PENRITH CITY COUNCIL

MAJOR ASSESSMENT REPORT

Application number:	DA21/0225
Proposed development:	Demolition of existing structures and construction of 2-3 storey boarding house containing 64 rooms and a manager's residence, basement parking, landscaping and stormwater works.
Property address:	27 Park Avenue, KINGSWOOD NSW 2747 28 Park Avenue, KINGSWOOD NSW 2747
Property description:	Lot 12 DP 29528 Lot 11 DP 29528
Date received:	6 April 2021
Assessing officer	Lucy Goldstein
Zoning:	SEPP WSA - Affected by Obstacle Limitation SEPP WSA - Affected by Wildlife Buffer Zone Zone R3 Medium Density Residential - LEP 2010
Class of building:	Class 3 , Class 7a
Recommendations:	Refuse

Council is in receipt of a Development Application for the Demolition of Existing Structures and Construction of a 2-3 Storey Boarding House Containing 64x rooms and a Manager's Residence, Basement Parking, Landscaping and Stormwater works at 27-28 Park Avenue, Kingswood NSW 2747.

Figure 1: Extract of Eastern Elevation showing maximum height in the south-east corner of the building

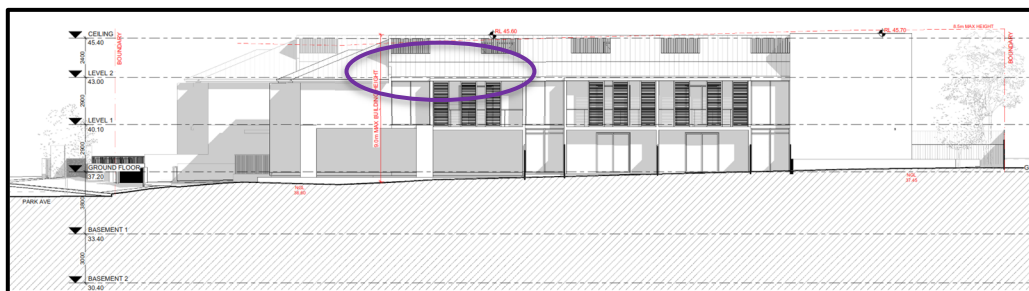
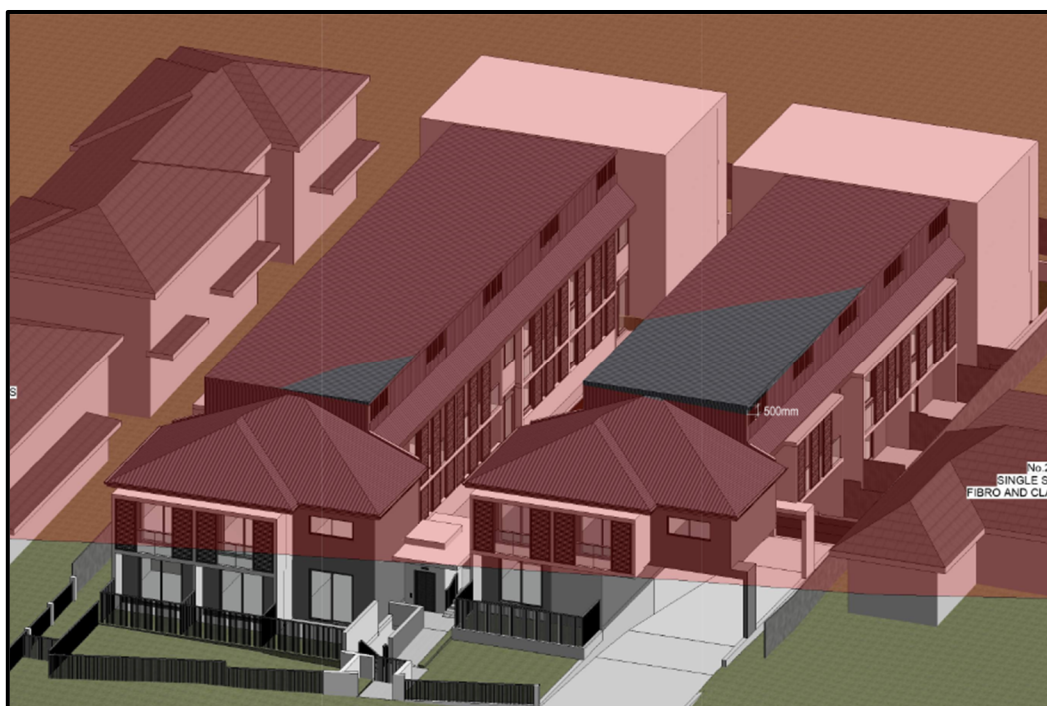
In this regard, the request has not adequately demonstrated that compliance with the development standard is unreasonable or unnecessary in the instance of the case, or and that there is sufficient environmental planning grounds to justify contravening the development standard. Further, the request has not adequately demonstrated that the proposal will be in the public interest. As a result of the

non-compliance, the development is considered to have adverse impact on the amenity of surrounding residences, and provide a poor level of amenity for future occupants. The breach to the building height is considered to speak to the proposal being an over-development of the site.

- The proposed non-compliant building height accentuates the Development's incompatibility with desired character. Circumstances of the Site and the Development do not indicate that compliance with the standard might be considered unnecessary or unreasonable. The proposed non-compliance would be inconsistent with objectives for building height, and there are no apparent planning grounds for the proposed non-compliant elements of the Development.

Appendix B – Vehicle Swept Paths

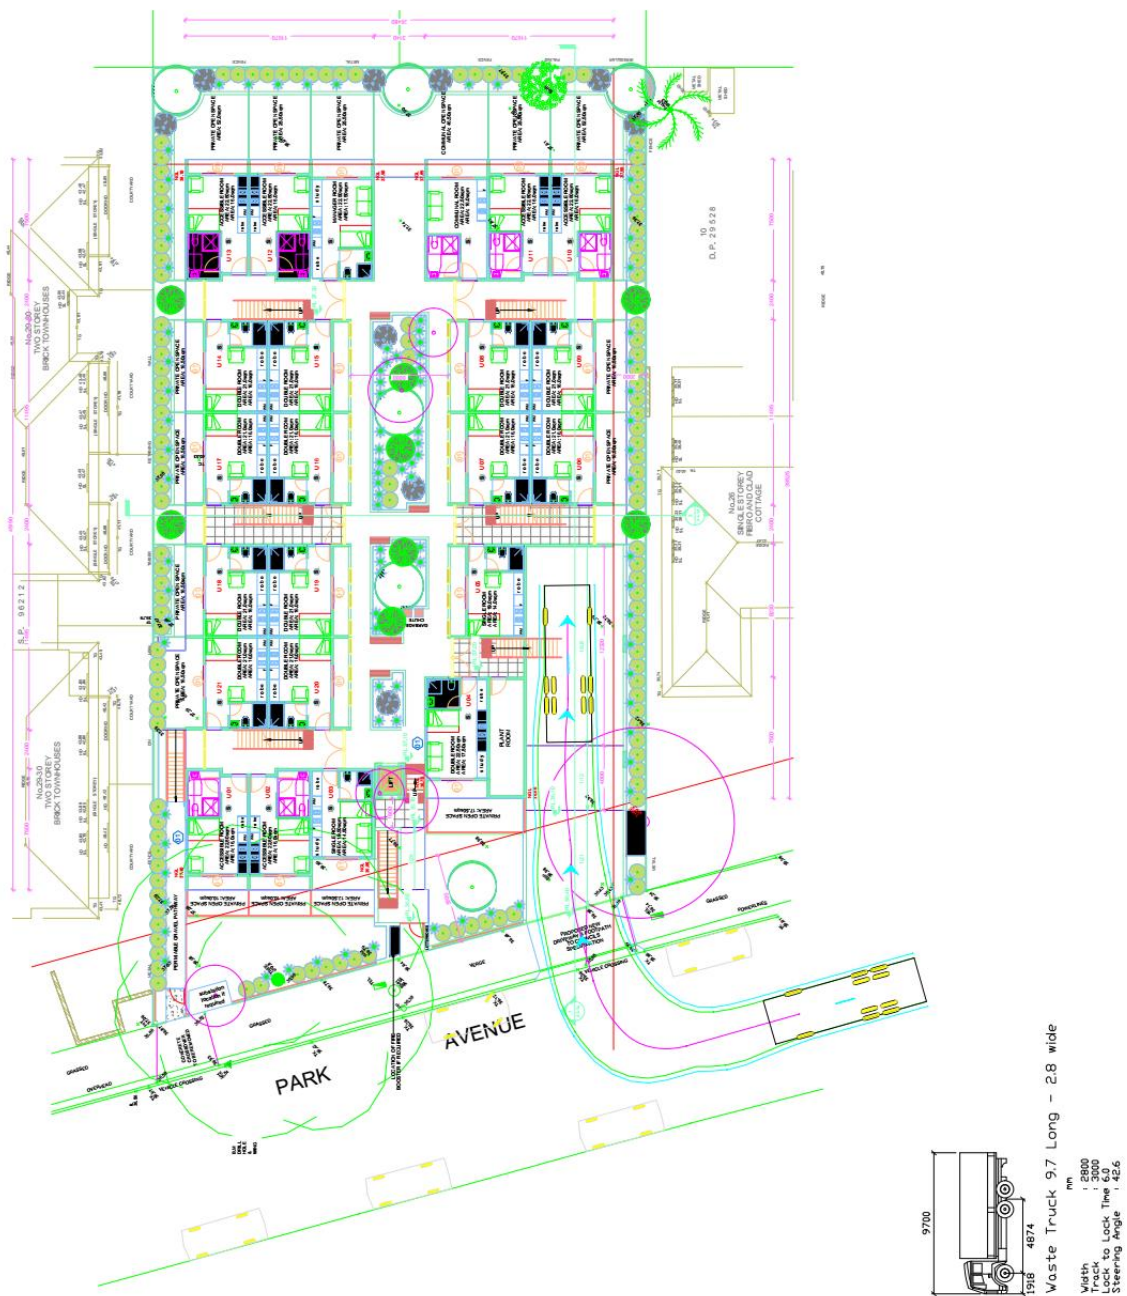
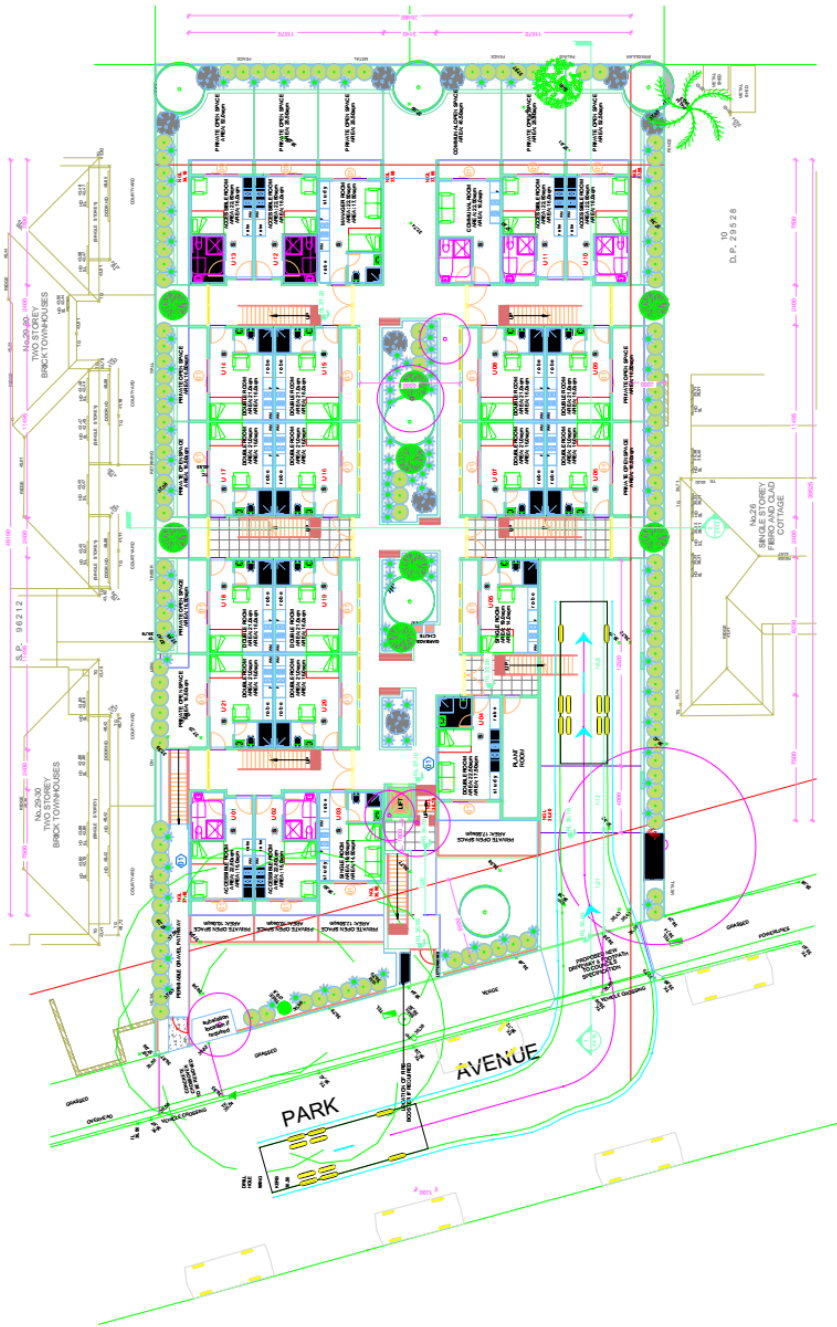
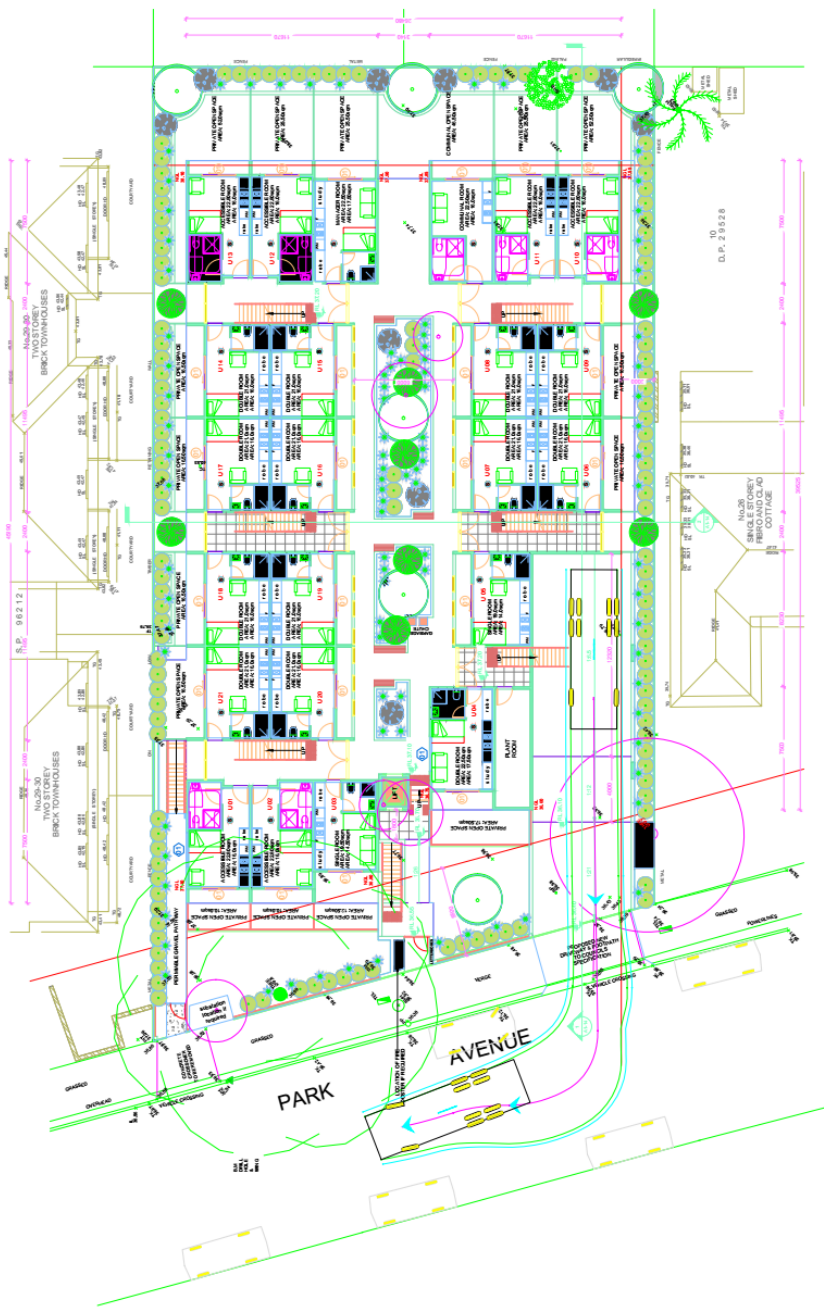
- **Section 2.2.3:** Swept paths for the waste vehicle accessing the site do not show that 500mm clearances to the truck is achieved for all onsite maneuvers as required by Council's waste guideline. Swept path models are required to illustrate how Council's standard waste collection vehicle will enter, service and exit the site safely and effectively, with a 500mm unobstructed clearance from all obstructions for the vehicle's ingress and egress manoeuvres, including in scenarios when cars are parked on either side of the road in front of the development.
